ADDENDUM NUMBER: Four (4)

TITLE: 1411921050 (IFB) BGS Standby Emergency Diesel Generator Integration

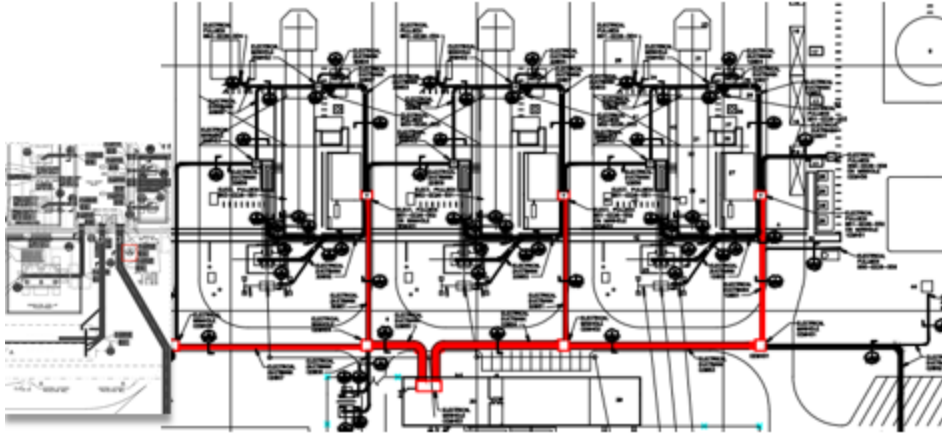
1. **Question:** We wanted to confirm #12 Question / Answer from Add#3 below - see pics. We also wanted to confirm the manhole/duct bank details for Bldg 54.

12. **Question:** The drawing on page 2 of the Layout and Underground Conduit does not show the 4th duct bank in red or Building 54. Please advise.

Answer: The drawing on page 2 of the Layout and Underground Conduit set is continued on page 9 of the same set. The drawing on page 9 will show the duct bank going towards building 54 from the west-most manhole highlighted on page 2.

Answer: The way it is laid out above is exactly correct. The manhole in question is manhole “CEMH05” in the manhole details. The duct bank in question is “section 20” (from pg. 9 and 10).
